**12A Parkes Street, Harris Park**

*Independent Flood Assessment  
Final Report*

**City of Parramatta Council**

Figure 5 Extract from DA/1263/2016 Plans

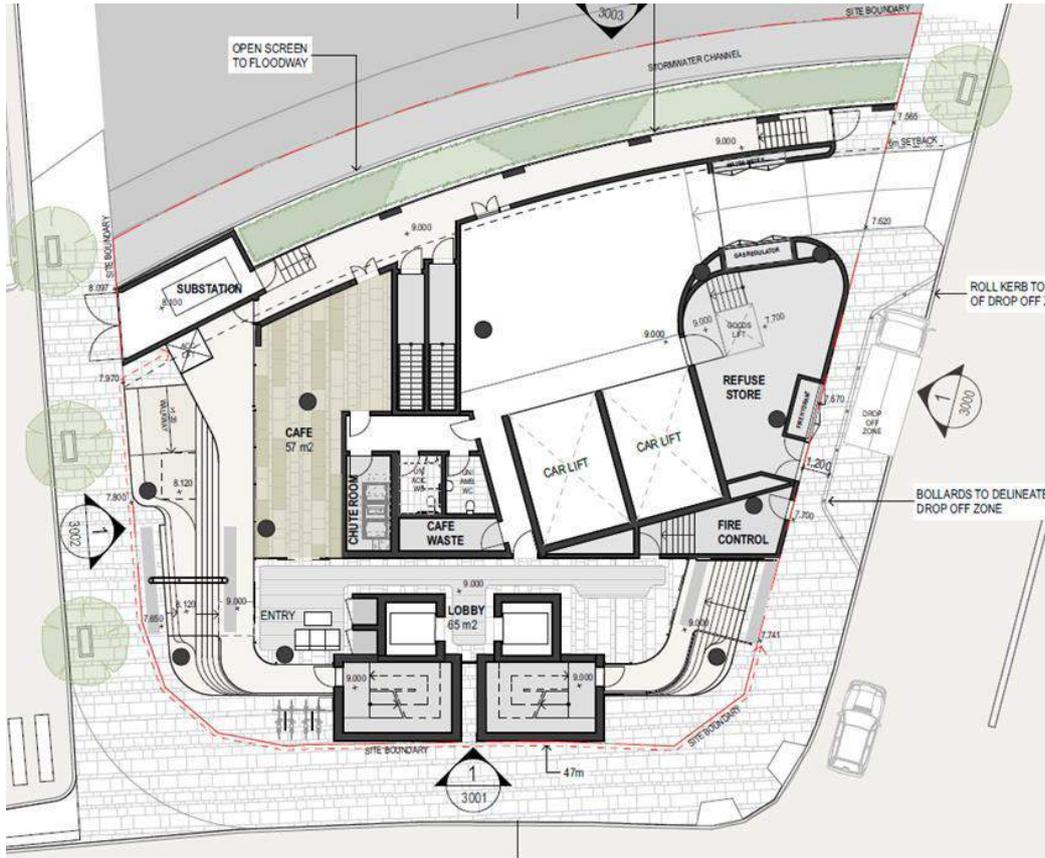
Figure 5 is an extract from the 2016 development application for the site. It shows ground levels around the perimeter of the site which represent existing pavement levels. It

is noted that the pavement in Charles St in the north western corner is about 8.1m AHD placing it 0.35m higher than the 1% flood level at this location and nearly 0.5m higher than the 5% flood level. It would therefore be physically impossible to have either of those flood extents in this location but that is at odds with the mapped flood extents in Figure 2 and Figure 3.

The consequence of this raising is that the flood extents shown along Charles St in Figure 2 and Figure 3 are not correct and the whole of Charles St between Parkes St and Hassall St is above the 5% AEP flood level and the footpath along the eastern side of Charles St is above the 1% AEP flood level.

It is also noted that the footpath at the corner of Parkes St and Wigram St is proposed to be built at about the level of the 1% AEP flood peak and will have a rising gradient towards Charles St. Charles St has a continually rising gradient from Parkes St to Hassall St and Hassall St rises above the reach of the probable maximum flood (PMF) as shown in Figure 5 .

Figure 6: TUFLOW Modelled 1% AEP Flood (Lyall and Associates, 2018)

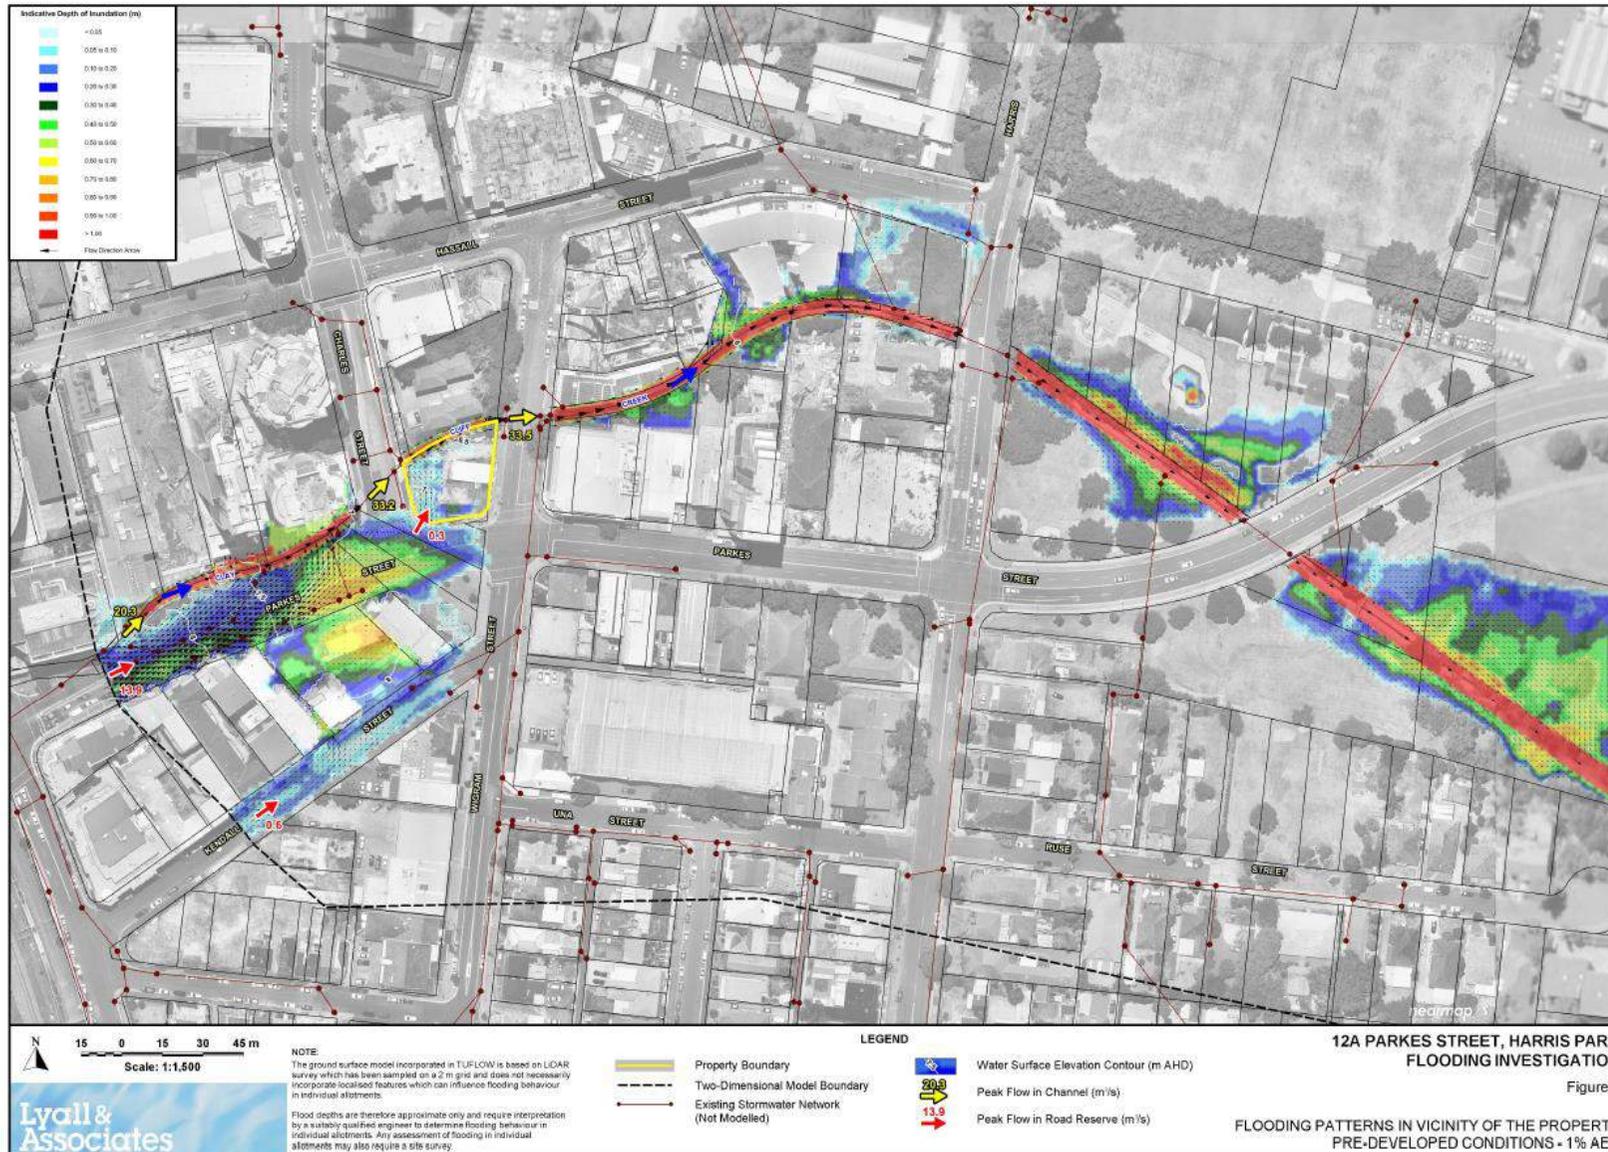
The TUFLOW model shows that once all of the overland flows along Parkes St (including contributions from catchments to the south) have found their way into Clay Cliff Creek, the canal has sufficient capacity to convey all of the 1% AEP flows at least beyond Wigram Street. Figure 6 show the flood depths and flow rates for the 1% AEP in the TUFLOW model.

It is noted that the 1% AEP mapping in Figure 6 assumes ideal flow conditions in the canal which experiences supercritical flow in these conditions. Should there be a disturbance to the flow in the canal (e.g. debris catching on the bed or edge of the canal), subcritical flow conditions could occur in which case the flood level adjacent to the site could rise to above the top of the canal but no higher than 8.2m AHD.

There is a stark contrast between the 1% AEP flood extent in Figure 3 derived from the MIKE 11 model and that in Figure 6 derived from the TUFLOW model.

However, Figure 6 shows that according to the TUFLOW model the majority of the site is unaffected by the 1% AEP flood and where the water flows across the site it is less than 0.2m deep. In a 1% AEP flood the site would have access to Wigram St which sits above the 1% AEP flood level.

Figure 7 Flood Hazard Mapping (SKM2005)

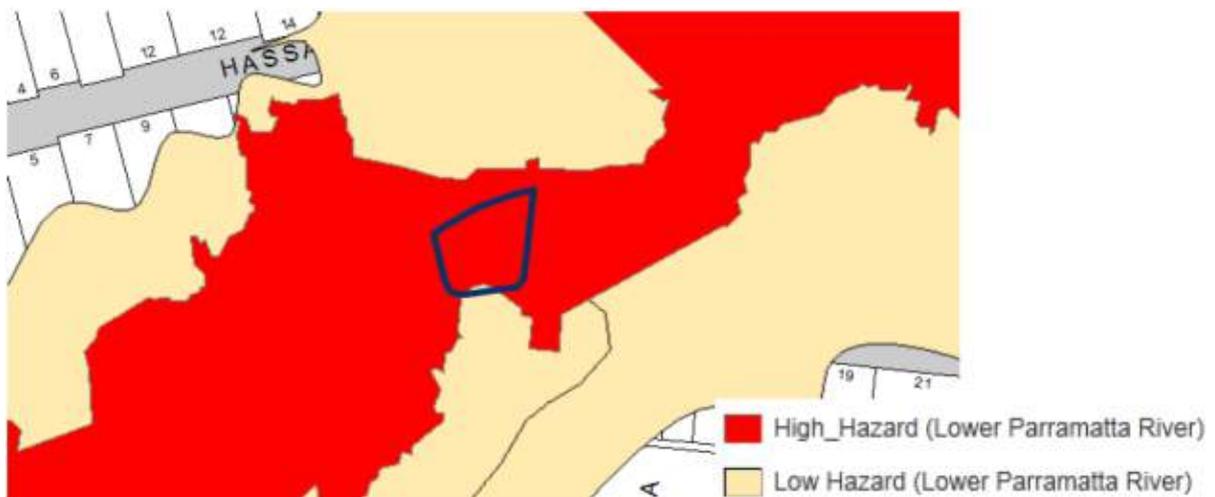
As shown in Figure 3 the site sits fully within an area mapped by Council as being below the 1% AEP (100 year) flood and Figure 7 shows the site is also classified as high hazard. These two maps combined therefore indicate

*Figure 9 Wigram St Bridge*

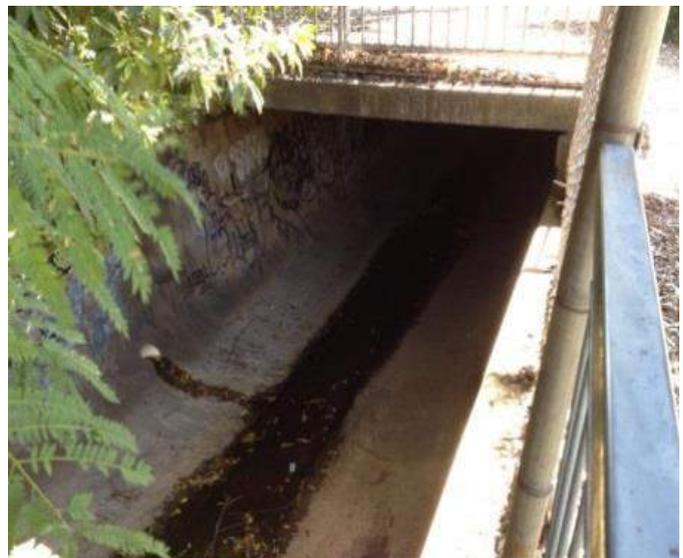
Blockage of the Wigram St Bridge could potentially increase flood levels on the site and neighbouring properties. However, the Wigram St Bridge opening is larger than the Jubilee Park culvert and similar to the Charles St Bridge (Figure 9 to Figure 10) and so any large items which pass through the upstream culverts would also pass under the Wigram St Bridge. It is also noted that the channel is fenced on both sides along Parkes St so that there is no potential for large items to enter the channel after it emerges from under the Heritage Tower.
